Railyard Re-development
(Second St. S. of Hazeldine Ave.)

Traffic Impact Study

Traffic Impact Study
Railyard Re-development – (Second St. S. of Hazeldine Ave.)

Figure 189b: Master Plan - Proposed Conceptual Water

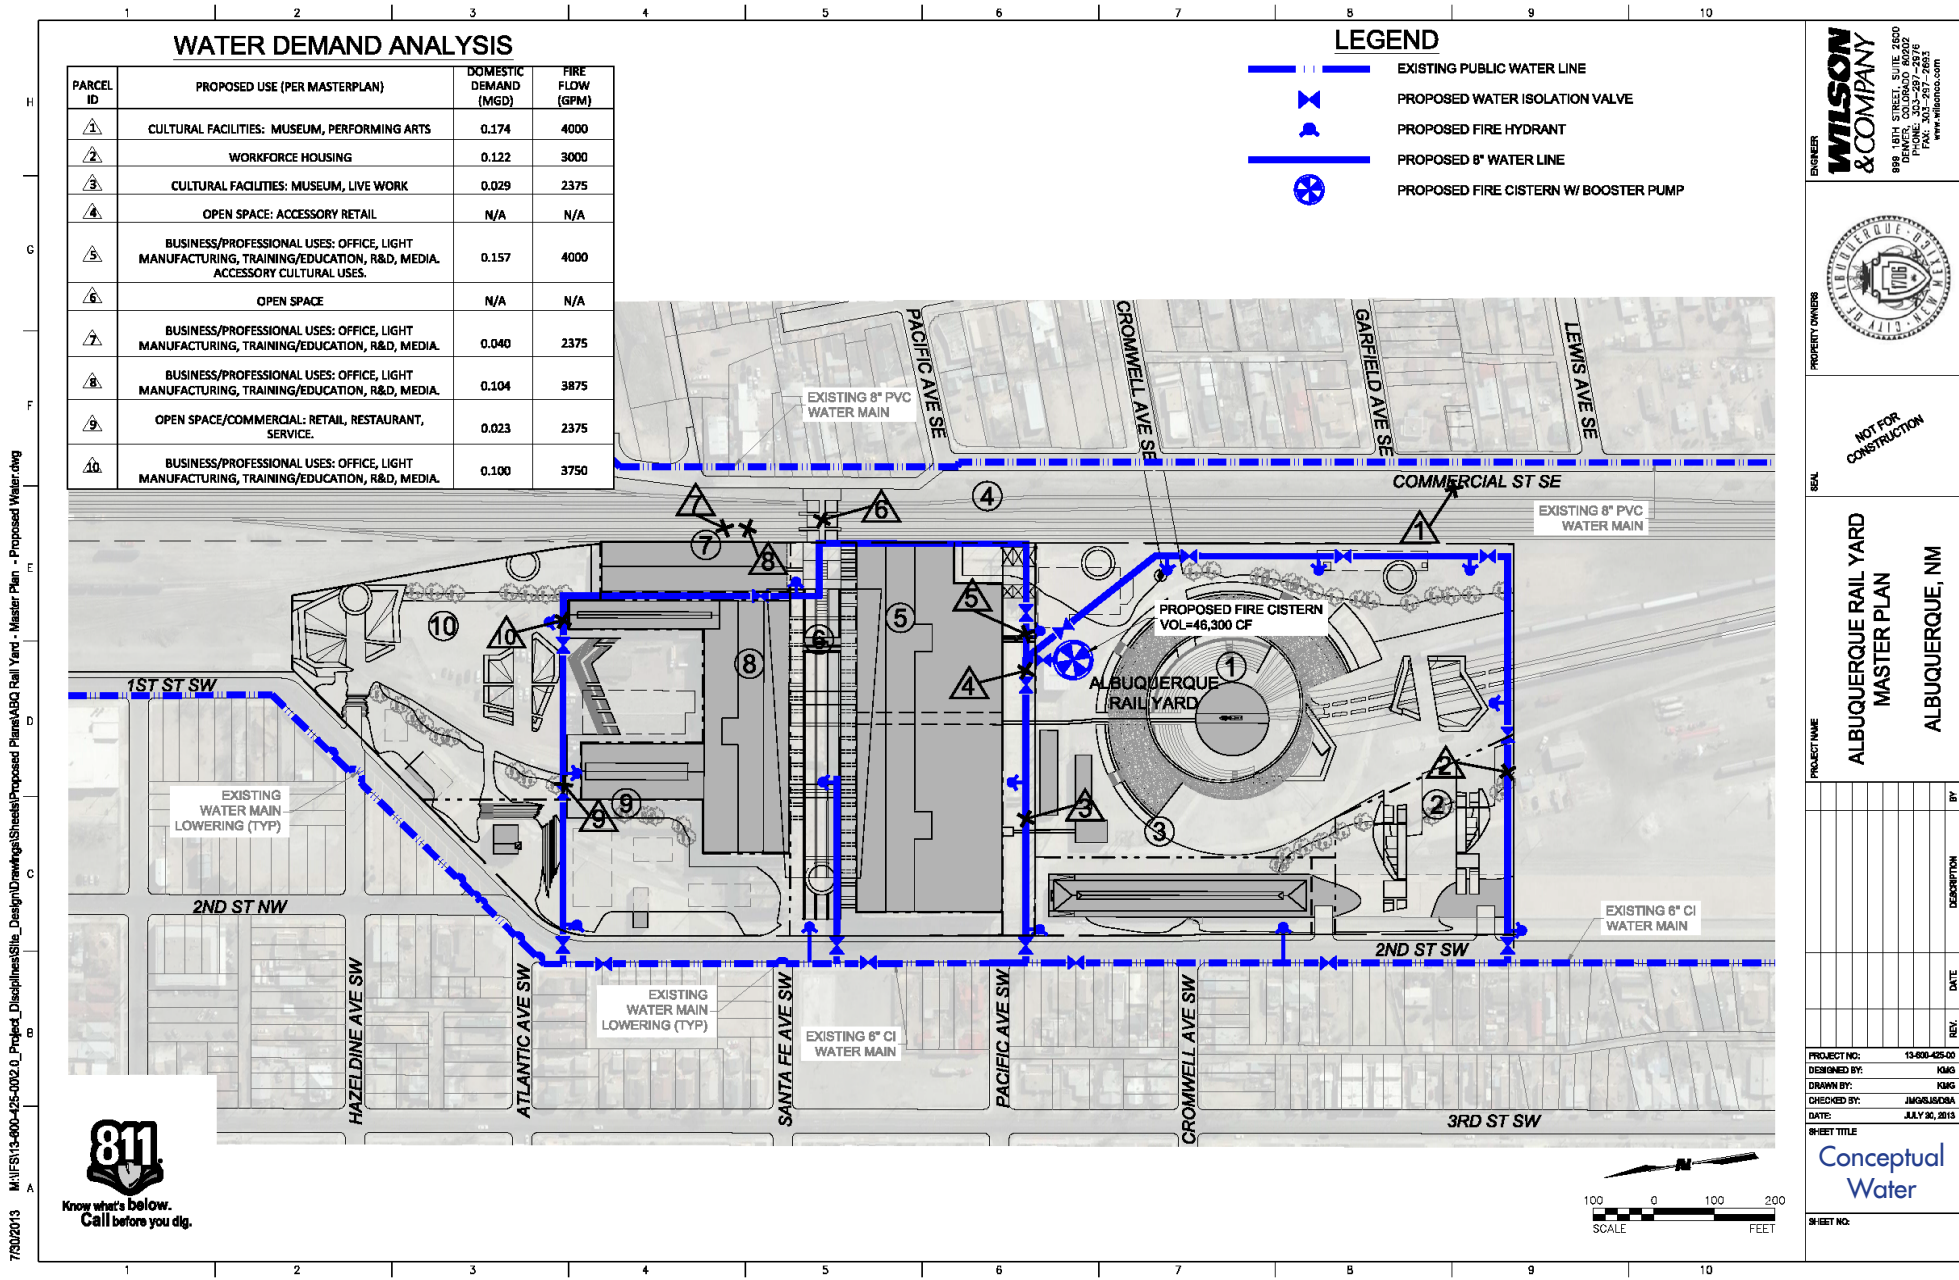
****Note:** See attached [Master Plan Proposed Sanitary Figure 20b Conceptual Wastewater](#) for analyses point locations and Parcel ID.

Figure 1920b: Master Plan - Proposed Conceptual Wastewater

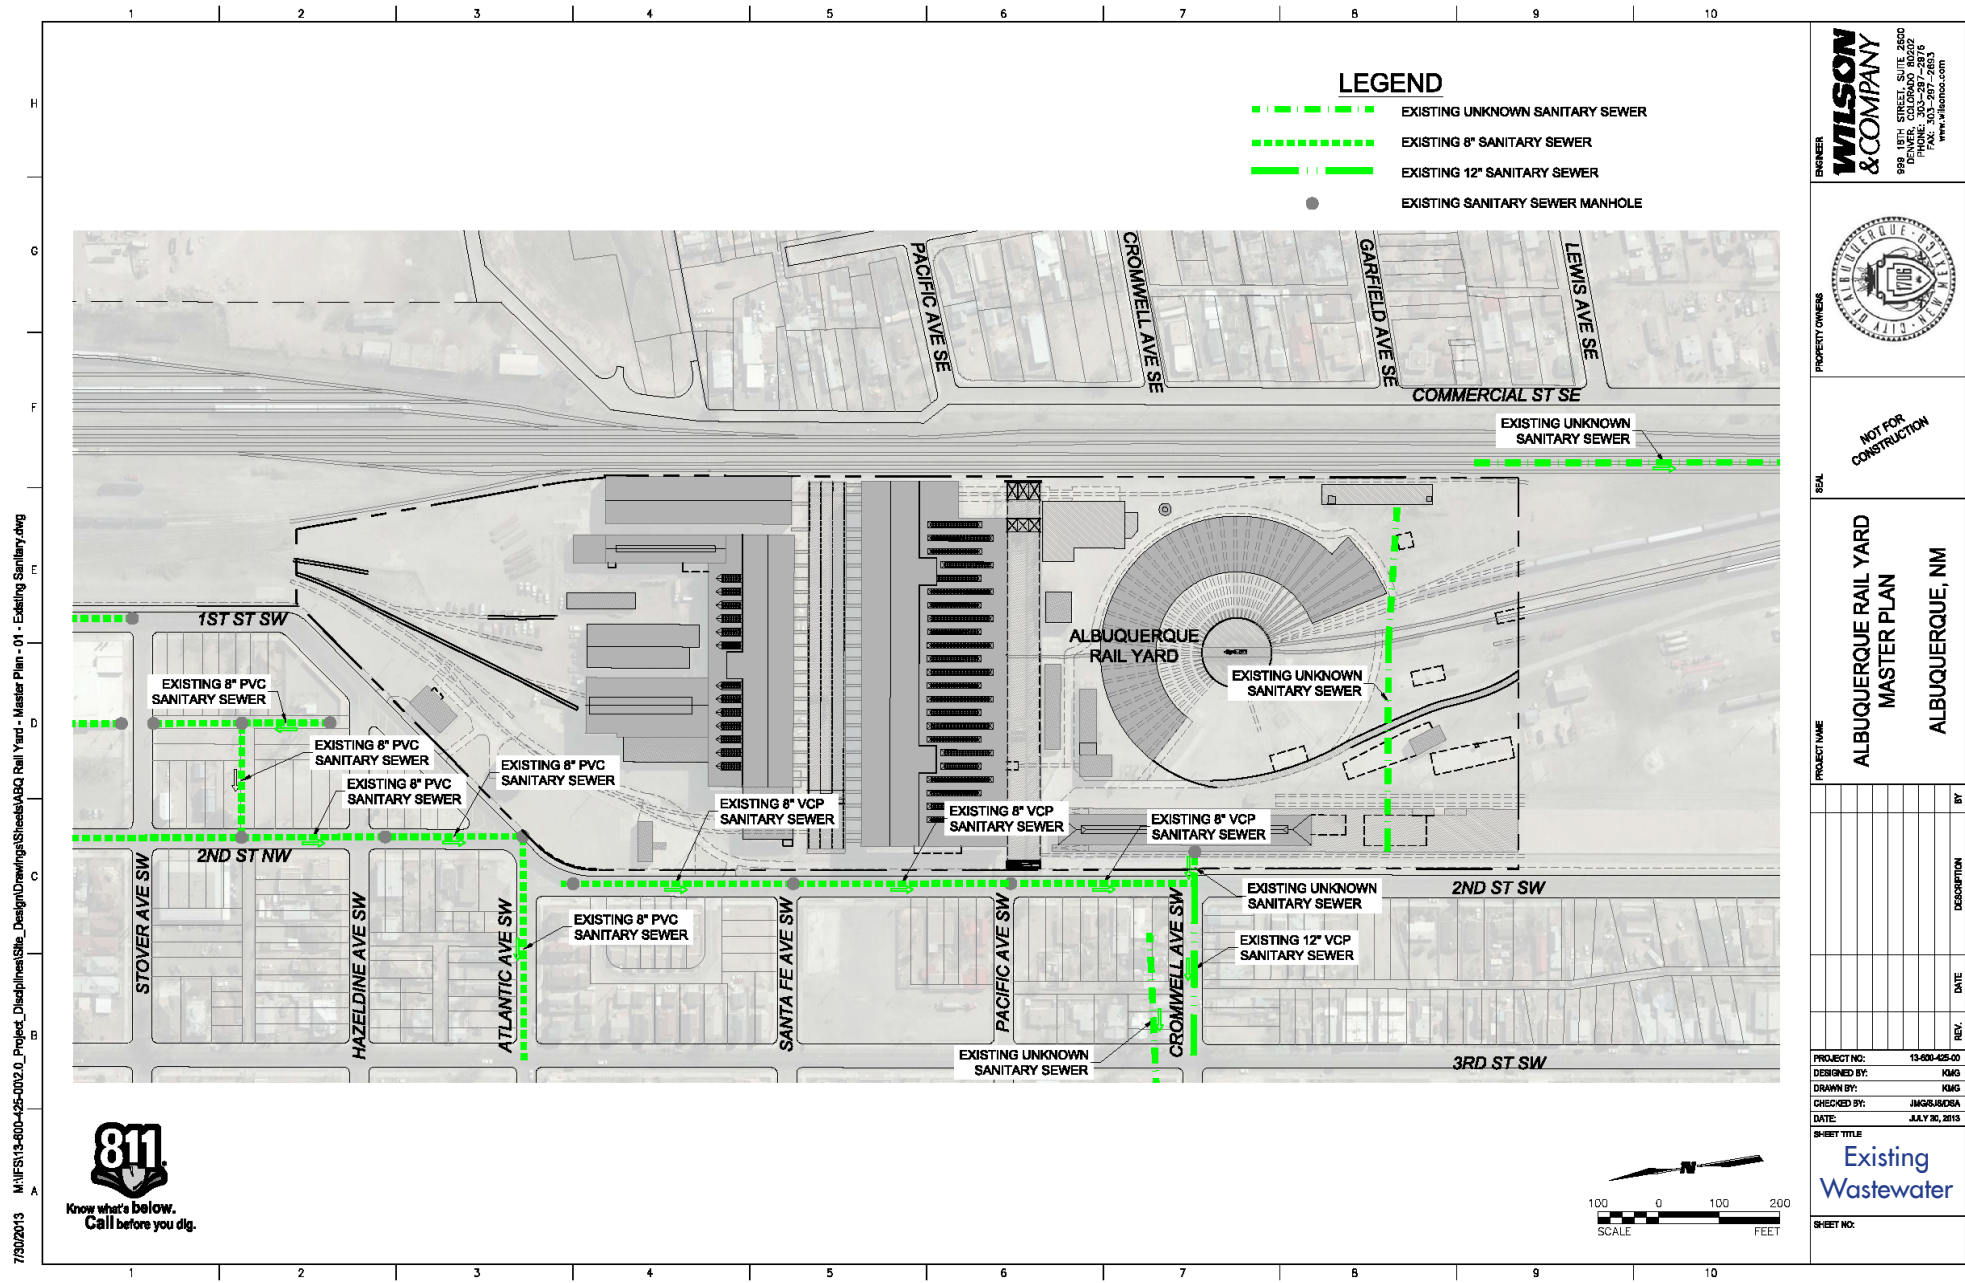
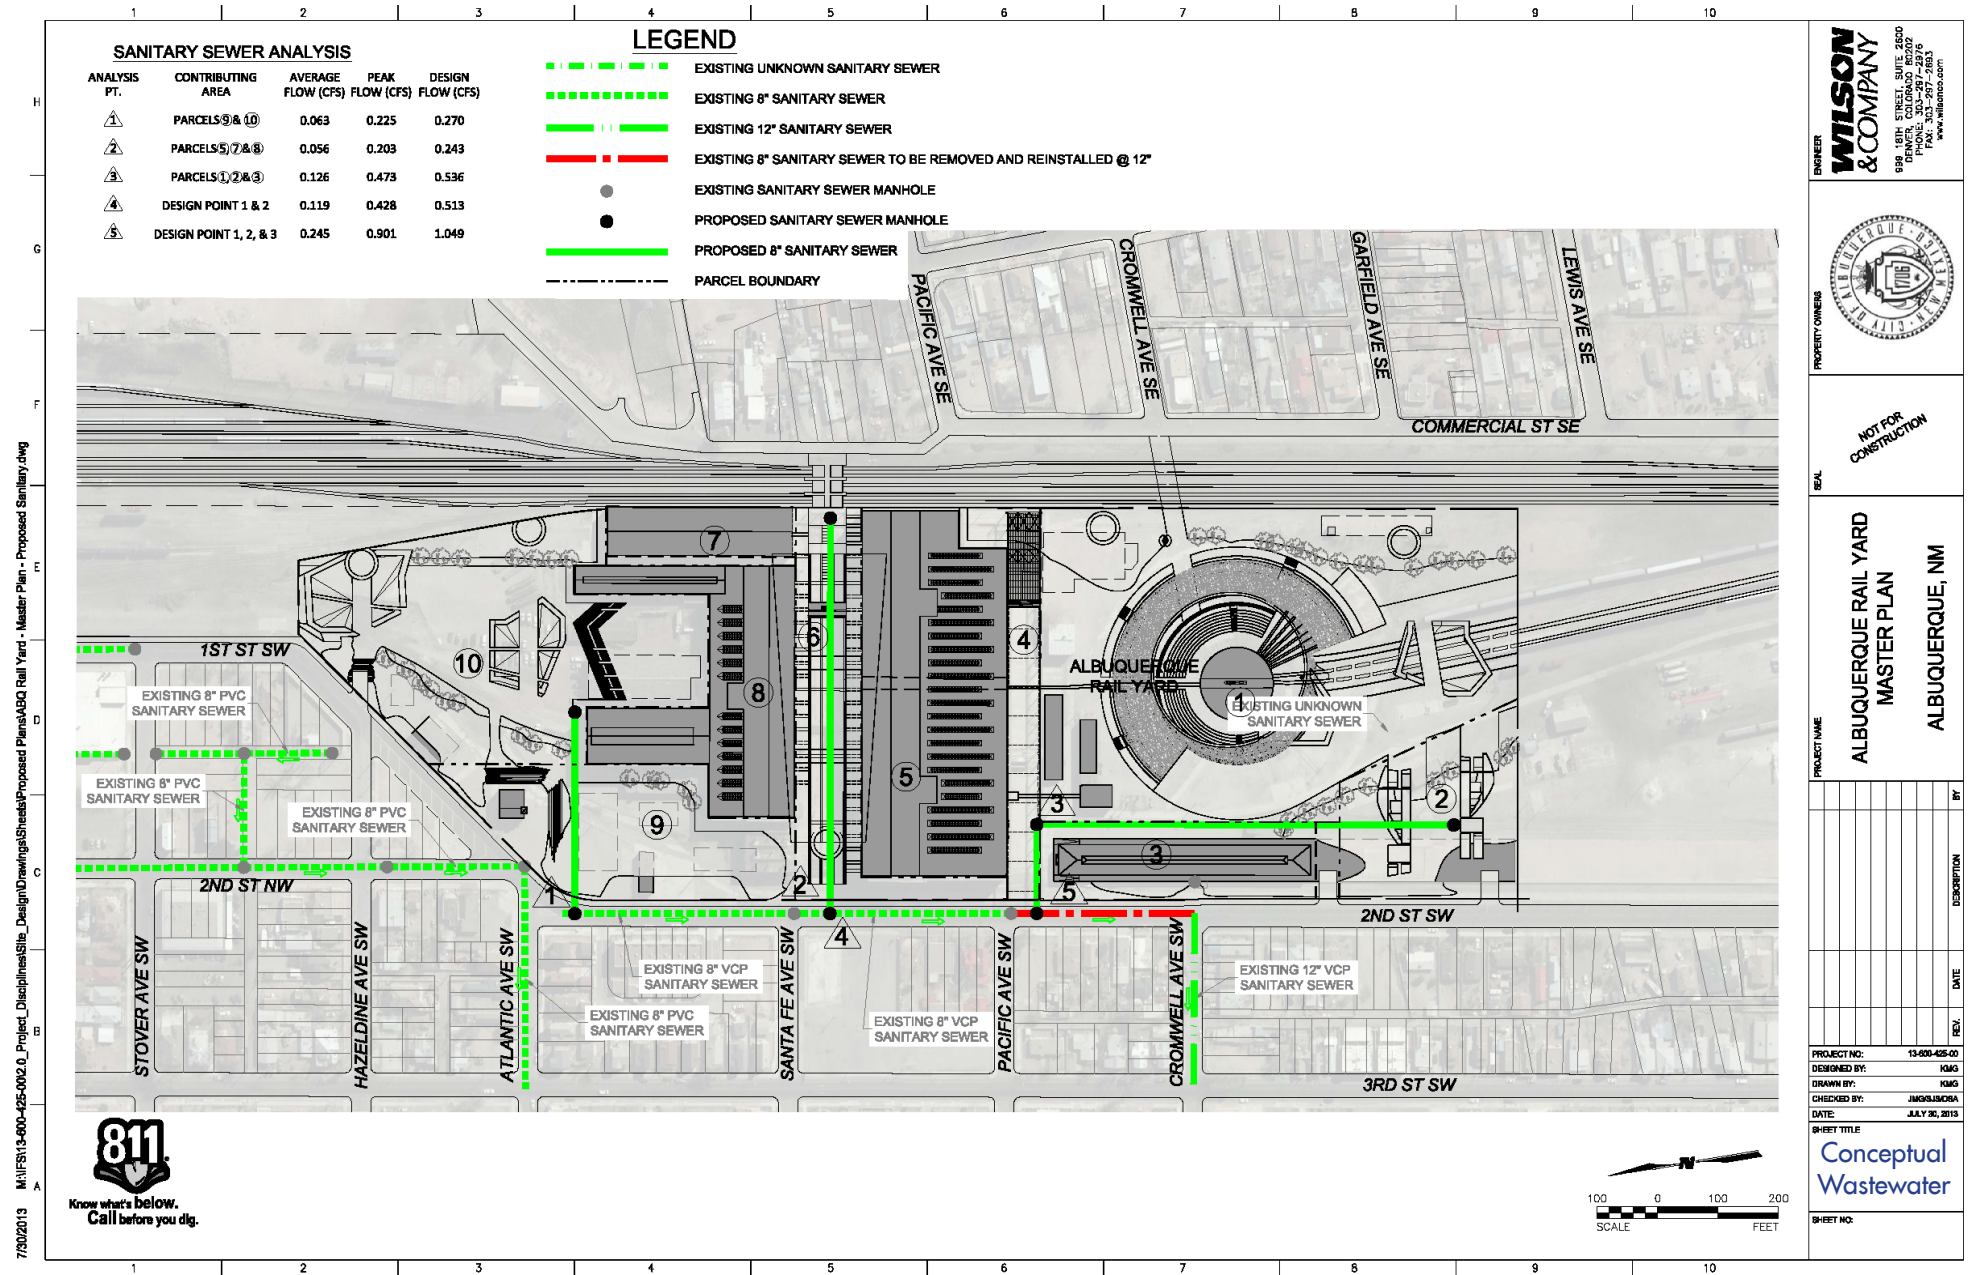
South of analysis point 5, the ~~report master plan~~ proposes the replacement of the 8" VCP with a 12" PVC sanitary pipe, due to the additional flow that will be contributed from analysis point 5, which is a combination of analysis point 1, 2, and 3. The project flow at this portion of the sanitary sewer system will be 1.05 cfs. An analysis was done using FlowMaster to determine the allowable capacity in the proposed 12" PVC pipe. The results of the FlowMaster analysis it was determined the allowable flow capacity of the proposed 12" PVC pipe was 2.52 cfs, therefore a remaining capacity of 1.47 cfs (58.3%) would be allowable for future developments.

Attachments: [Master Plan Existing Wastewater Sanitary](#)
[Master Plan Proposed Sanitary Conceptual Wastewater](#)
 Spread Sheet of Analysis Points with Calculated Flows
 Section 2 of Chapter 24: Sanitary Sewer Design Criteria
 CCD Table 2.04.3 – Commercial/Industrial Flow
 Factors
 FlowMaster Worksheet for Existing 8" VCP @ Assumed
 0.5% (Allowable Capacity)
 FlowMaster Worksheet for Existing 12" PVC @ Assumed
 0.5% (Allowable Capacity)
